**From:** "Ballard, Jared" <JBallard@pizzagalli.com>  
**To:** "mc@portlandmaine.gov" <mc@portlandmaine.gov>  
**Date:** 12/8/2008 3:59:54 PM  
**Subject:** 84 Marginal Way - Final C of O

**From:** "Judy L. Johnson" <jljohnson@harriman.com>  
**To:** "Gregory Cass" <GEC@portlandmaine.gov>, <buildinginspections@portlandmaine.gov>, <jmb@portlandmaine.gov>  
**Date:** 12/4/2008 12:19:47 PM  
**Subject:** FW: 84 Marginal Main Entry Handrail

Title: CONCRETE STAIR WITH HANDRAIL  
MAIN ENTRY

Project: 84 MARGINAL WAY

### CONCRETE STAIR DETAIL - MAIN ENTRY

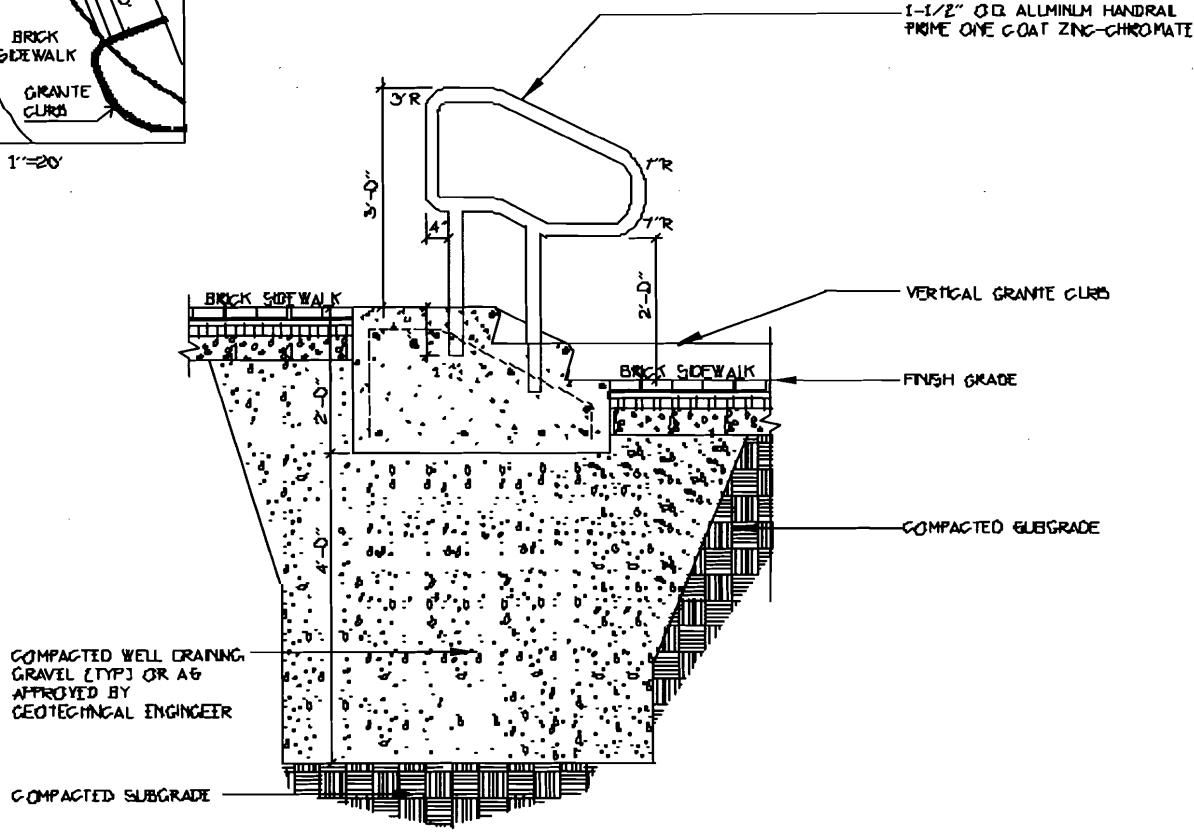
Item 2-Main Lobby Exterior Rail - We will be procuring and installing the rail shown in the attached sketch at the center of the main lobby stairs only. In accordance with discussions between Judy Johnson and Cpt. Cass this will be acceptable.

Bob Metcalf and I have looked at the entry at 84 Marginal Way - and felt that the best option for a possible handrail location is in the center of the doors (please see attached sketch). We consider this most similar to a monumental stair which requires handrails within 30" of the natural path of travel.

Please review and let me know if this is acceptable to you.
